State of New Mexico
Energy, Minerals and Natural Resources

Form C-103
Revised July 18, 2013

WELL API NO. 30-015-31216
5. Indicate Type of Lease STATE ☒ FEE ☐
6. State Oil & Gas Lease No.
7. Lease Name or Unit Agreement Name Pathfinder 19 State Com
8. Well Number. #1
9. OGRID Number 331165
10. Pool name or Wildcat Illinois Camp Morrow, North (Gas)

Perforations 10540' - 10610'**Proposed P&A Procedure
Permian Resources
Pathfinder 19 State Com #1
API – 30-015-31216****Bubble Test at all perforations****APPROVED
GC 10/22/25**

CURRENT WELLBORE DIAGRAM

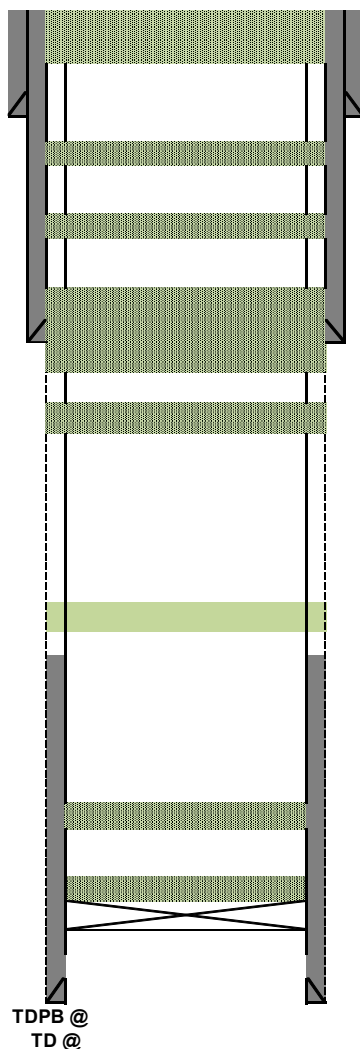
6. RIH 5-1/2" CIBP and set at 10490'. TOH. - Test Casing 500psi/3min - Bubble Test
7. MIRU logging truck. Run CBL to log TOC to surface w/zero pressure. **NOTE:** Results of CBL may change the following plugs. Electronic copy of CBL to be sent to NMOCD. (Note: T/S 2001 indicated TOC @ 6200')

8. Spot 15 sx cmt on CIBP @ 10490' - T Perforations.
9. **8b. Spot 50 sx cmt 9960' - 9500' - T Morrow, Atoka, Strawn**
Note: Any plugs requiring a WOC & Tag. 2% CaCl will be added to the slurry. WOC 4hrs. and Tag.
